# PONTIAC

## Service Craftsman News

No. 3 S-270

March, 1955

Fig. 5 Tail Gate Cable Support Guide

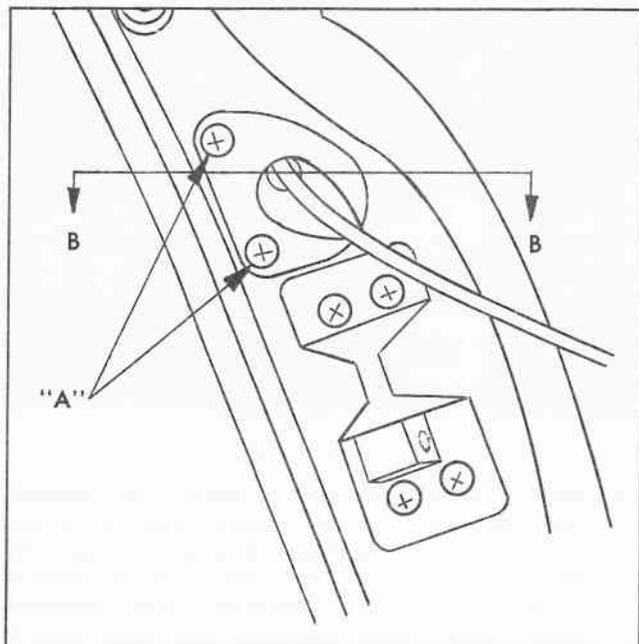
If the tail gate support cable binds at the rubber grommet installed on the back body opening facing reinforcement, the following procedure may be used to replace the rubber grommet with a new wax-impregnated felt grommet. The new grommet is re-

1. Remove the two screws "A", which secure the tail gate support cable guide, and slide the guide out of the back body opening. See Fig. 5.
2. Remove the rubber grommet which is cemented to the back body opening facing reinforcement.
3. Slip the new grommet, Part No. 4666373, over the cable and into position against the back body opening facing reinforcement. See Fig. 6.

Fig. 11 Hydra-Matic and Synchro-Mesh Choke Pistons

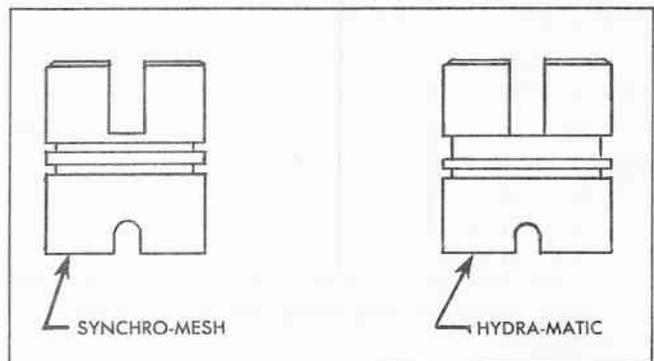
A slightly different choke piston is used on the Synchro-Mesh carburetor. The Synchro-Mesh piston has two narrow grooves of equal width while the Hydra-Matic choke piston has one wide and one narrow groove. (See Figure 11). These pistons should not be interchanged.

Fig. 12 Slot Cut in Compressor Mounting Bracket

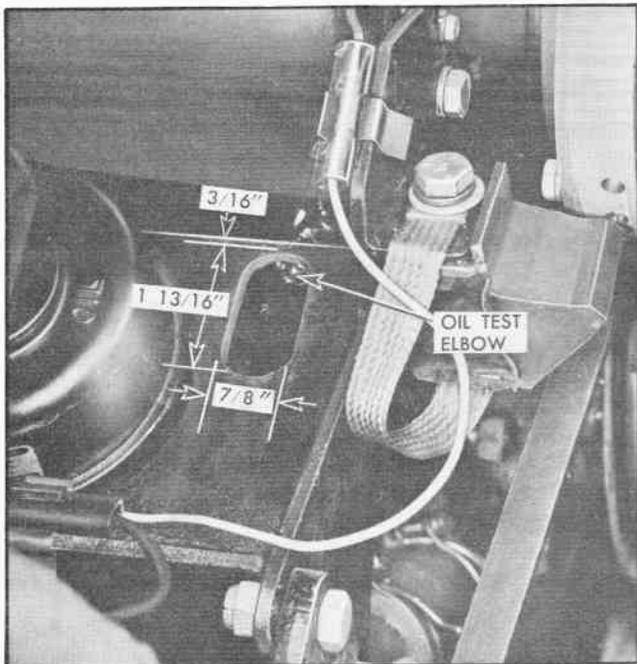
Cut a slot in the compressor mounting bracket to allow a gauge line and Schraeder adapter J-5420 to be attached to the oil test elbow. The slot should start  $3/16$ " from the compressor edge of the bracket and be  $7/8$ " wide and  $1\ 13/16$ " long. (See Figure 12). One method of making the slot is to drill two  $7/8$ " holes  $1/16$ " apart and then cut the web from between them with a cold chisel. The suggested time allowance for cutting this slot is .6 hrs.

A similar hole will be incorporated in the bracket in production as soon as possible.

Fig. 14 Power Brake Secondary Seal Expanders

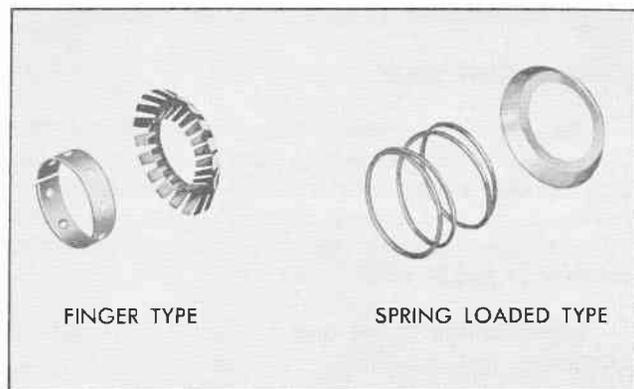
A special finger type expander and spacer assembly Part Number 5454862 has been released for the secondary seal in the Moraine Power Brake unit. (Refer to Fig. 5-35, Book I Preliminary Shop Manual.) This expander provides more positive sealing between the outer diameter of the cup and the I.D. of the plug. No problem has been encountered on Pontiac prior to the use of the expander, but anytime a unit which has an expander is disassembled, the expander should be re-installed when unit is reassembled. It is not necessary to add the expander to early production units which did not originally have it.

Temporarily a spring loaded expander (Fig. 14) was used in production. This expander is used without a spacer.

A finger type expander (Fig. 14) is the latest type and the only one which will be serviced. When the spring loaded type is encountered it may be re-used or the finger type can be used.

The finger type expander requires a new spacer. The new spacer has a 1/32" larger diameter and has a black oxide finish for identification.

Fig. 16 Headlamp Adjusting Chart

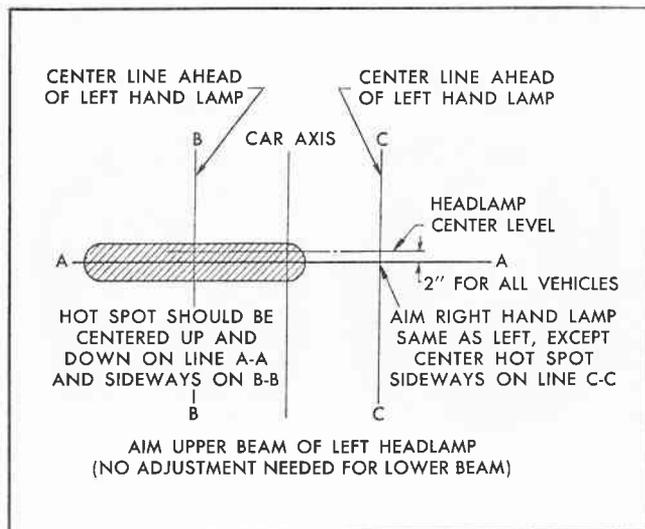
Aiming procedure on the new unit is the same as given in the 1949-1954 Pontiac Shop Manual with the exception that line A-A on the headlamp adjusting chart is now 2 inches below the headlamp center level instead of 3 inches. (See Fig. 16).

Fig. 17 Early and Late Type Direction Signal Wiring Harness to Housing Clamp

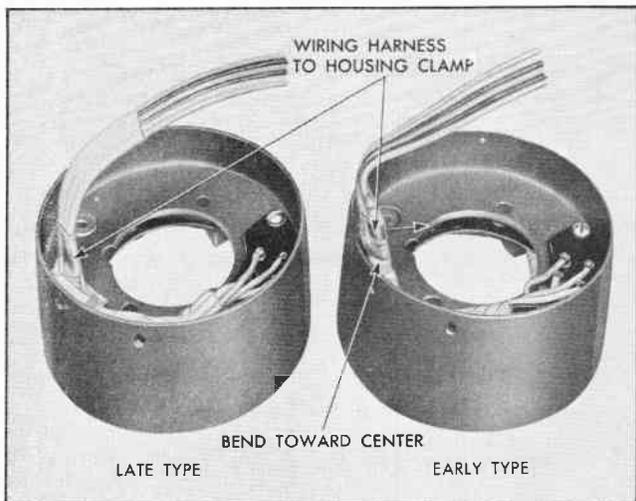
On some early production cars, the direction signal wiring harness contacts the gearshift lever support at the upper end of the steering column. On these cars the continual movement of the support, during shifting, chafes the wires and eventually cuts through the insulation causing a short circuit. This causes the direction signal fuse to blow making the direction signal and the hand brake warning lamp inoperative.

This condition has been corrected in production by the release of a new type clamp which more positively positions the wiring harness (See Fig. 17).

When this condition is encountered, remove the direction signal control assembly and replace the wiring harness and switch base assembly. Route the new wiring harness in the guide clamp and push it down through the clamp until it lies flush against the underside of the housing. Then bend the clamp around the harness to hold it securely in place. Before re-installing the control assembly, bend the clamp and harness toward the center of the housing to make sure it will not contact the gearshift lever support.
